L624-A.07.15	To: Official After Sales Network Subject: Seat update Date: 20/05/16 Pages: 5	
--------------	--	---

Seat update

All Lamborghini Model Huracan MY 15 from VIN **FLA00163** to VIN **FLA01657**.

Spare Parts.

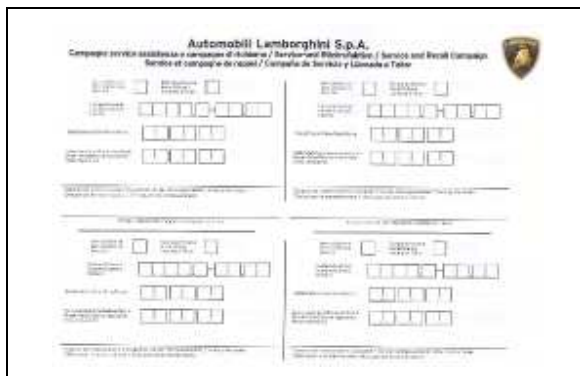
As a result of continuous product monitoring, Automobili Lamborghini Spa has decided to install a wiring reinforcement to prevent abrasion during seat movement.

P/N	Description	Q
4T0951195	Sheath	2
